ADDENDUM NO. 01

BCDM Architects
1015 North 98th Street, Suite 300
Omaha, Nebraska 68114

November 30, 2023

Arnold Elementary – Addition & Renovation
5000 Mike Scholl Street
Lincoln, NE 68524
&
Huntington Elementary Renovation
2900 North 46th Street
Lincoln, NE 68504
BCDM Project No. 5370-01

1 FIRST FLOOR DEMOLITION PLAN
AD1-1 1/8" = 1'-0" 0' 1' 8' 16'

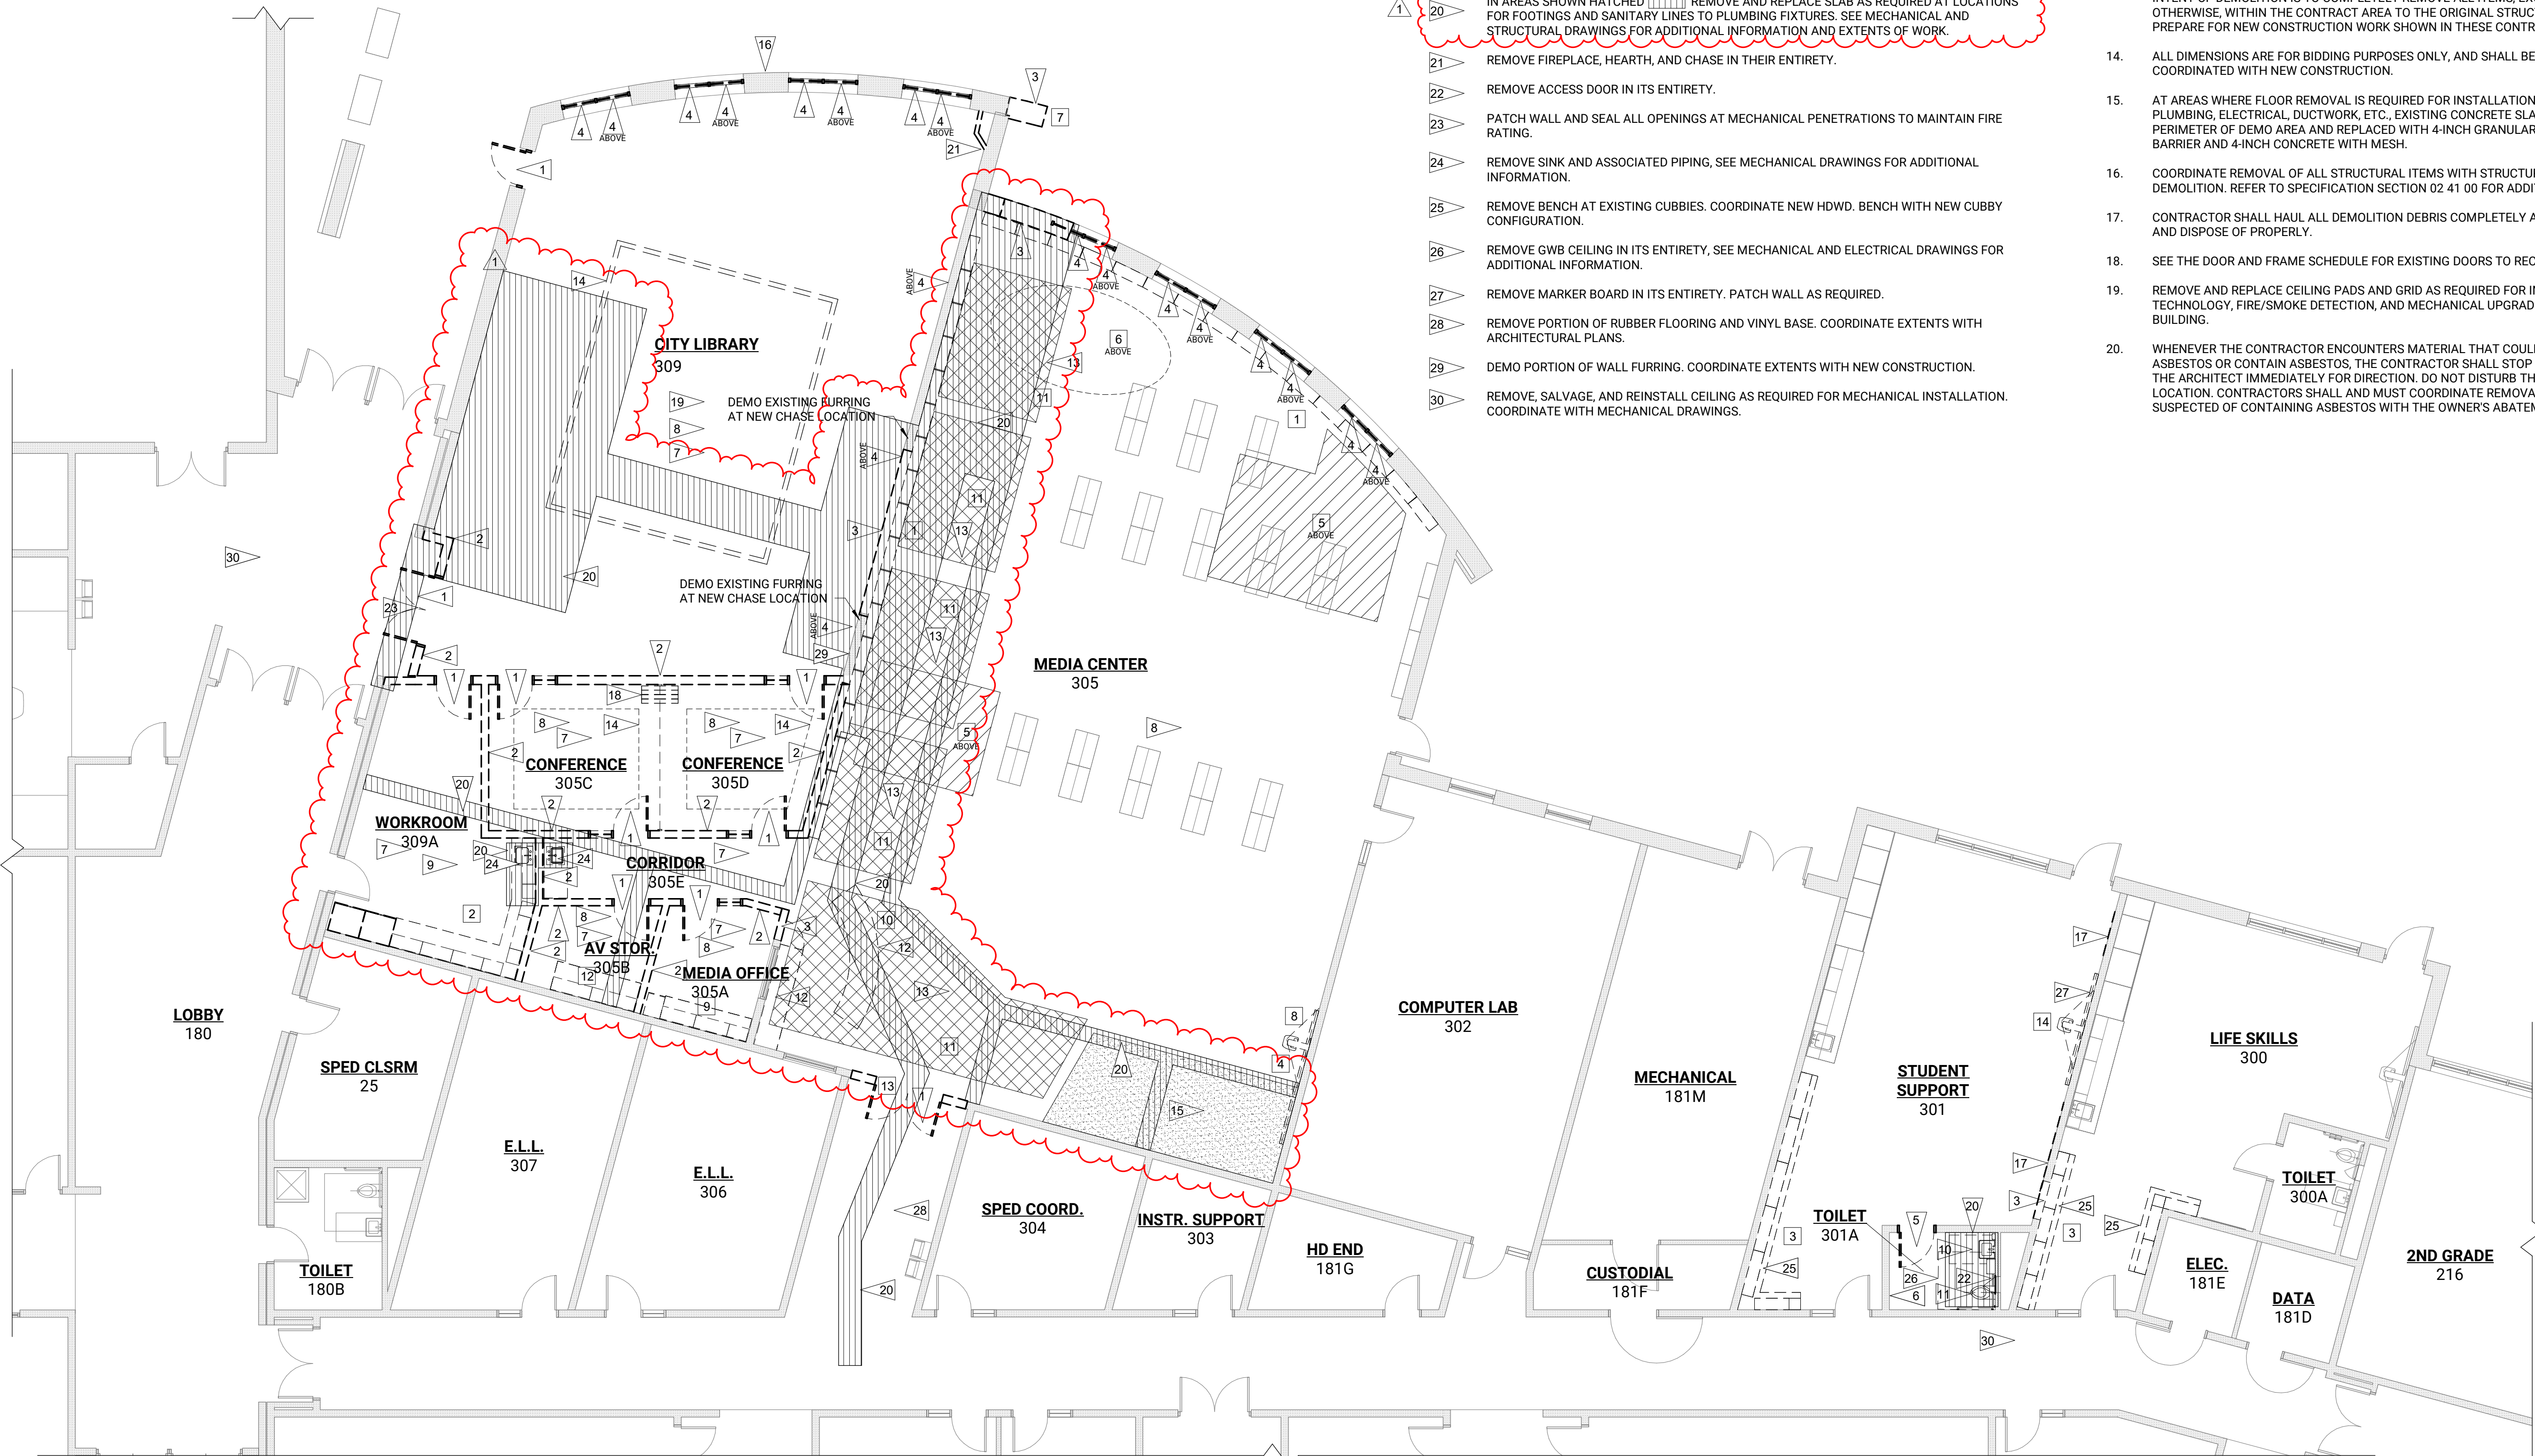
ARNOLD SHEET AD1-1, DEMOLITION PLAN

- a. Adjust flag note 20 to say, "IN AREAS SHOWN HATCHED REMOVE AND REPLACE SLAB AS REQUIRED AT LOCATIONS FOR FOOTINGS AND SANITARY LINES TO PLUMBING FIXTURES. SEE MECHANICAL AND STRUCTURAL DRAWINGS FOR ADDITIONAL INFORMATION AND EXTENTS OF WORK."
b. FIRST FLOOR DEMOLITION PLAN, adjust hatch for slab removal to accommodate new interior CMU walls.

PARTIAL POWER RISER DIAGRAM

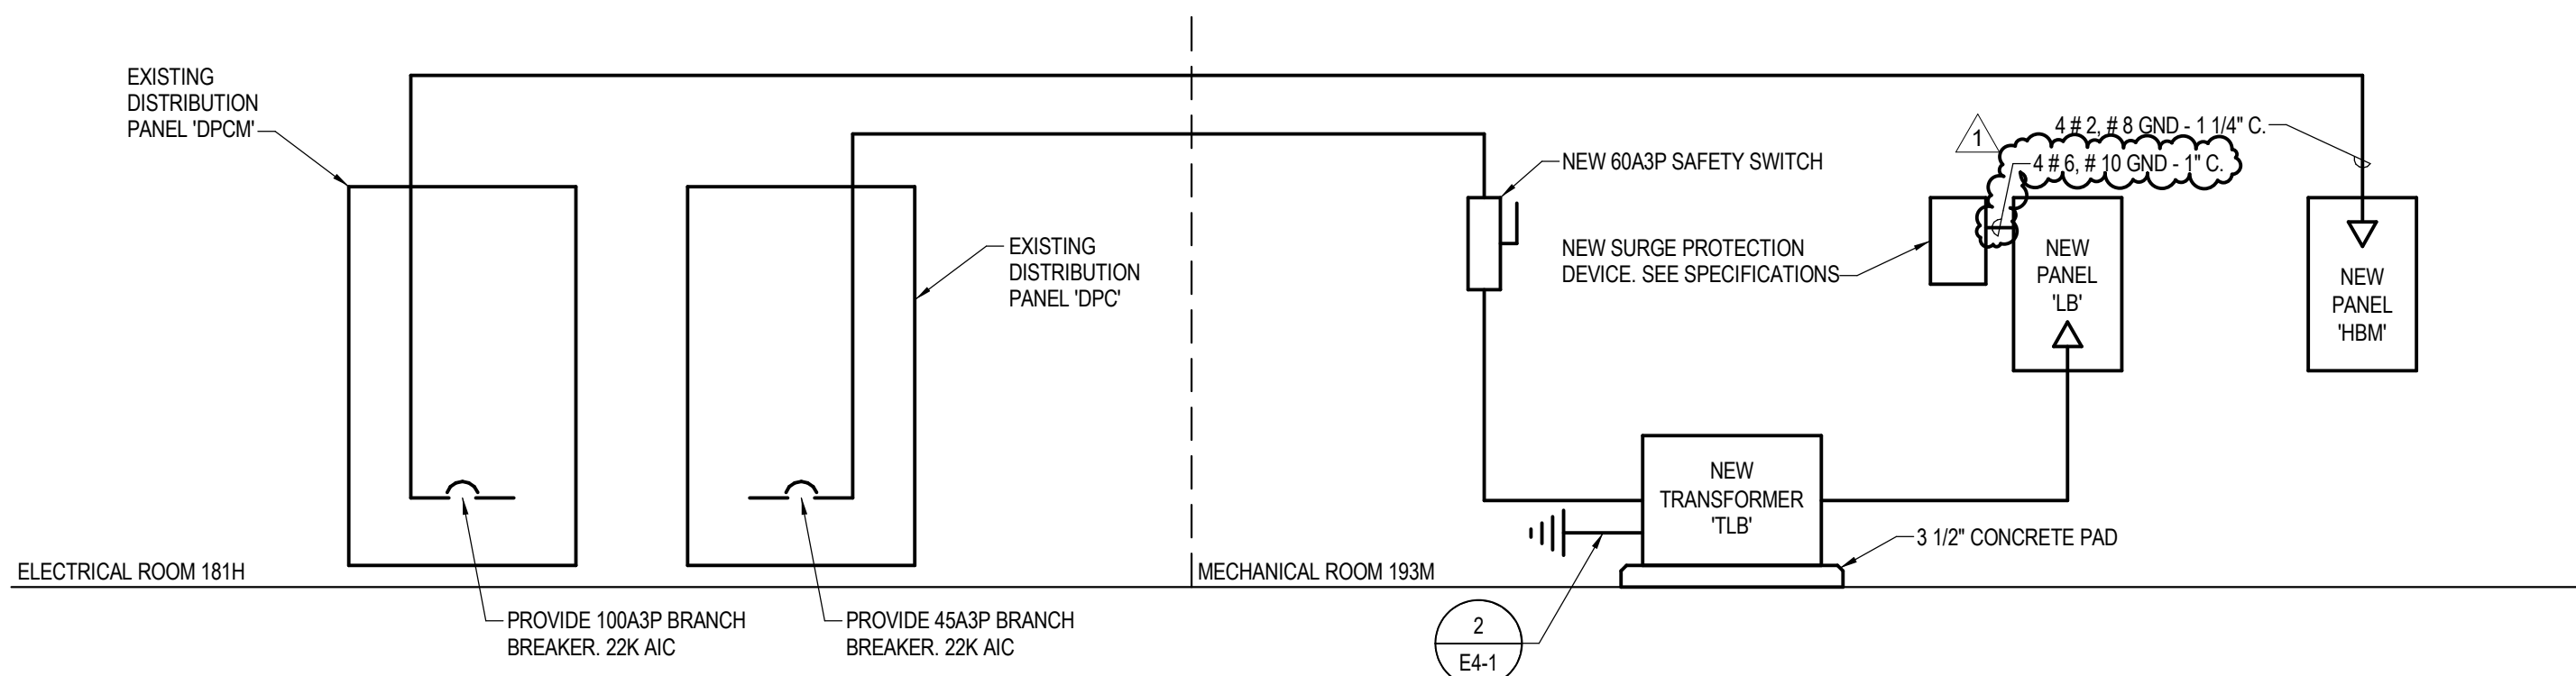
1ED7. Sheet E4-1 – Electrical Details and Power Riser Diagram

1. Partial Power Riser Diagram: Add four #6, #10 GND – 1" C between surge protection device and Panel LB.
2. See attached reissued sheet.
